STAFF REPORT

HEARING DATE: 7/21/2022

SUBJECT: H-2022-0036
Lavender Place Subdivision

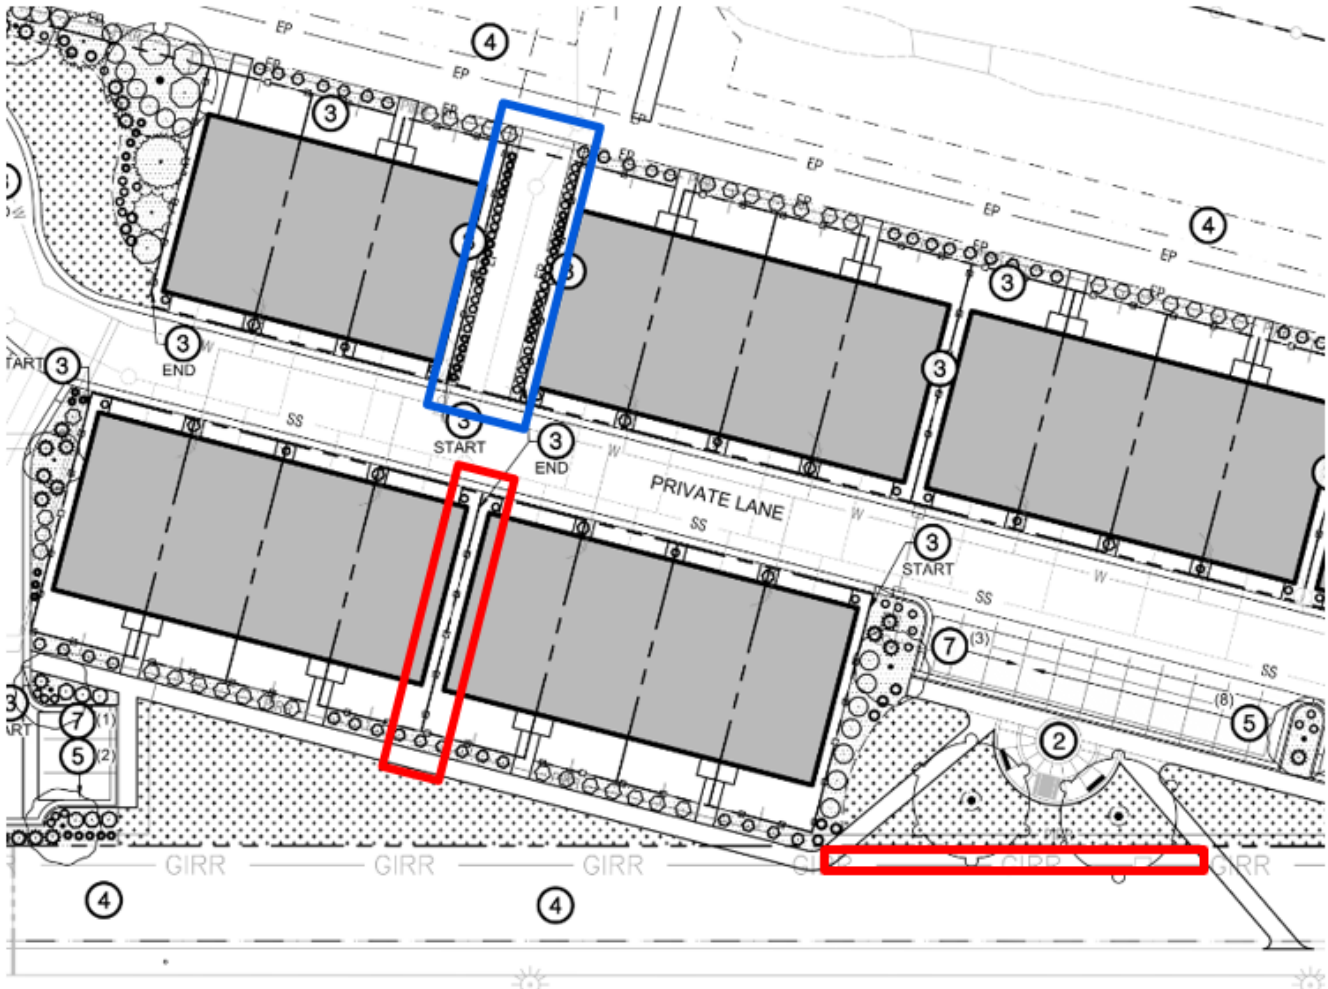
Per the submitted parking exhibit (see snip below), the Applicant is proposing to alternatively comply with the off-street parking standards by providing 18 parking spaces that will be designated for each specific unit. Each of the proposed residential units is shown with a 2-car tuck under garage providing the required off-street parking for 2-bedroom homes and meets the requirement of a 2-car garage for 3-bedroom units. However, due to the odd-shape of the parcel that creates a constrained building area, the Applicant proposed private streets and an alley-loaded product that does not readily allow for the required 20' by 20' parking pad for the nine (9) 3 and 4-bedroom homes. The Applicant placed the parking spaces directly across the private street from each unit to minimize the distance homeowners would have to traverse to access their additional parking spaces. In addition to the 18 parking spaces designated for the residents, the Applicant is also showing 7 additional guest parking spaces. NOTE: Parking is prohibited on the private street as well as along Lake Hazel and Bloomerang, the collector street where the private street takes access from.

Staff finds the proposed alternative as one option to meet the intent of the off-street parking requirements when accounting for the required density of the existing Development Agreement, site constraints, and limited access for the site. However, upon further review, Staff is recommending a modification to the ALT request: Staff recommends one parking space is allocated for each 3 or 4-bedroom unit instead of two spaces. It is difficult to predict the number of cars each unit will produce so Staff finds it more prudent to offer additional spaces for the entire development and not just the units with more bedrooms. Staff's recommendation would increase the number of guest spaces from seven (7) up to 16 spaces which should allow for more appropriate flexibility in their use for future residents and guests of this development. An additional option, should Commission or Council find the amount of off-street parking is not adequate overall, is to limit the number of units containing 3 or 4 bedrooms as a plat condition. Staff's Alternative Compliance findings for this request are below in Section IX at the end of this report.

- d. Revise the Alternative Compliance Parking Exhibit (Exhibit VII.D) to depict one (1) open parking space per 3 or 4-bedroom unit instead of two (2) consistent with Staff's analysis in Section V.H.

B. Preliminary Plat (dated: 3/30/2022)

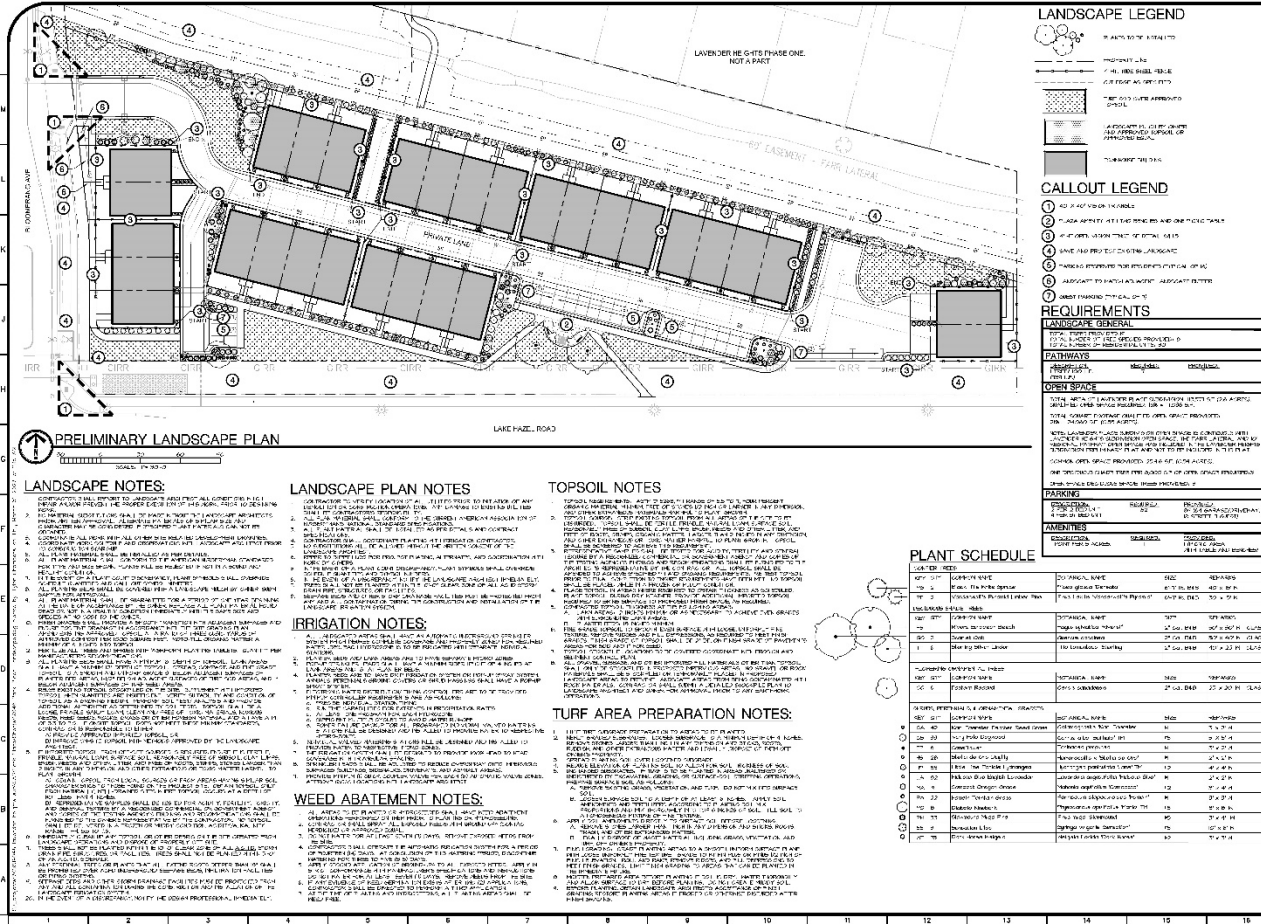
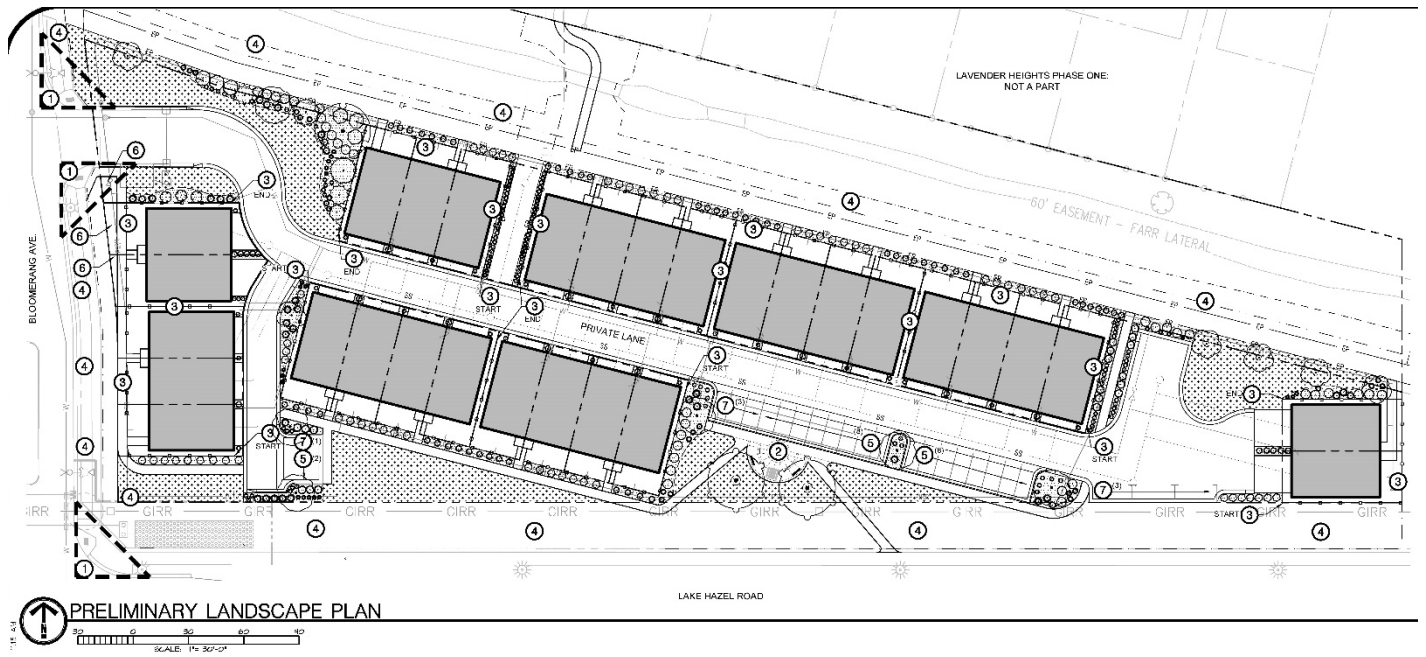
1. The preliminary plat included in Section VII.B, dated March 30, 2022, shall be revised as follows prior to the City Council hearing:
 - a. Revise the plat to add a new common, micro-path lot between Lots 24 & 25, Block 11 and an additional sidewalk connection near the plaza area for added pedestrian connectivity through the project to the existing arterial sidewalk along E. Lake Hazel Road, per the analysis in Section V.I.

- b. Add an additional common lot solely for the proposed private street per UDC 11-3F-4A and revise plat note #8 to reflect the new common lot.
 - c. Revise the placement and design of the driveways for Lots 32 and 33, Block 11 showing that the distance between the face of garage and the private street is 20' or 5' to help mitigate any conflicts of off-street parking and the proposed intersection of the common drive and private street, per the analysis in Section V.G. Parking in front of a garage less than 20 feet deep is prohibited.

C. Landscape Plans (date: 3/30/2022)

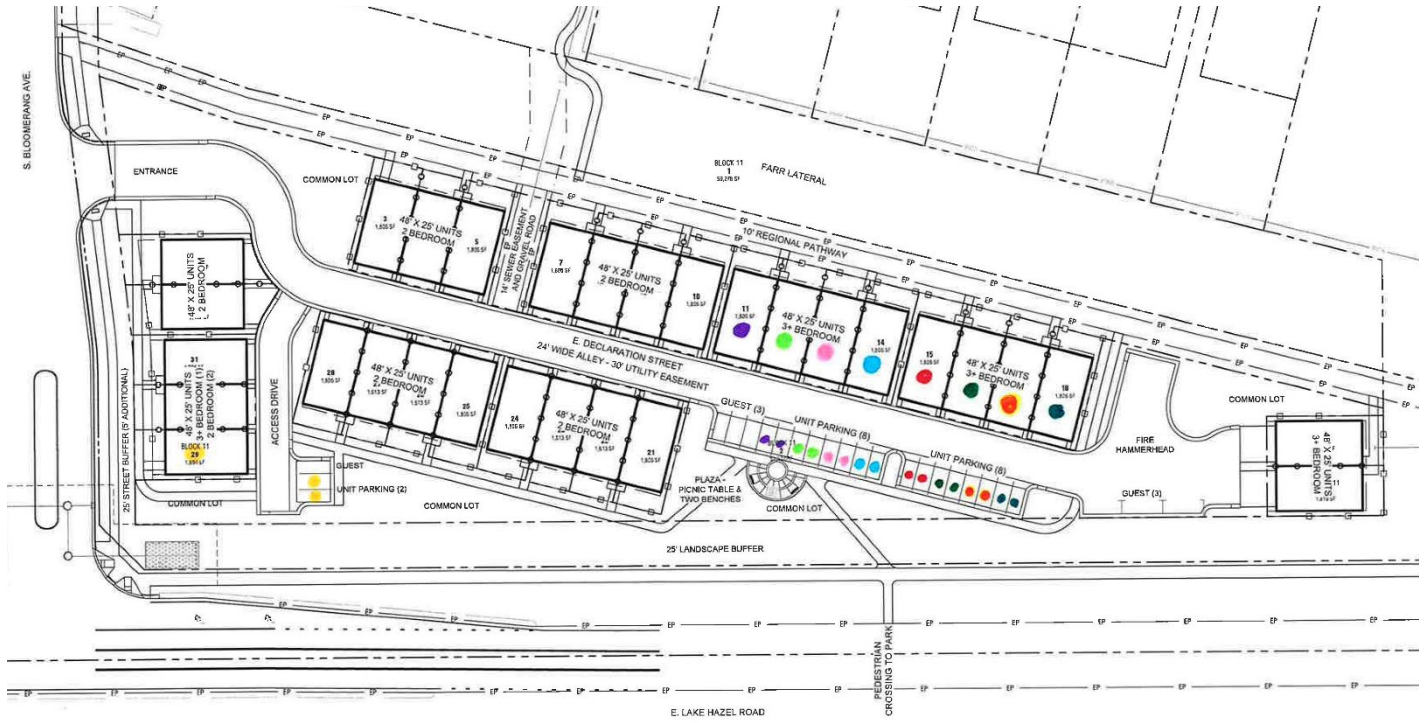
2. The landscape plan included in Section VII.C, dated March 30, 2022, shall be revised as follows prior to the City Council hearing:
 - a. Revise the landscape plan to match the plat revisions noted in VIII.A1 above.

- b. Add shrubs and other vegetative ground cover adjacent to the recommended new micro-path between Lots 24 & 25, Block 11.
3. City Council approved the submitted preliminary plat with a dead end street greater than 500 feet in length (approximately 680 feet), per provisions in UDC 11-6C-3B.4b.
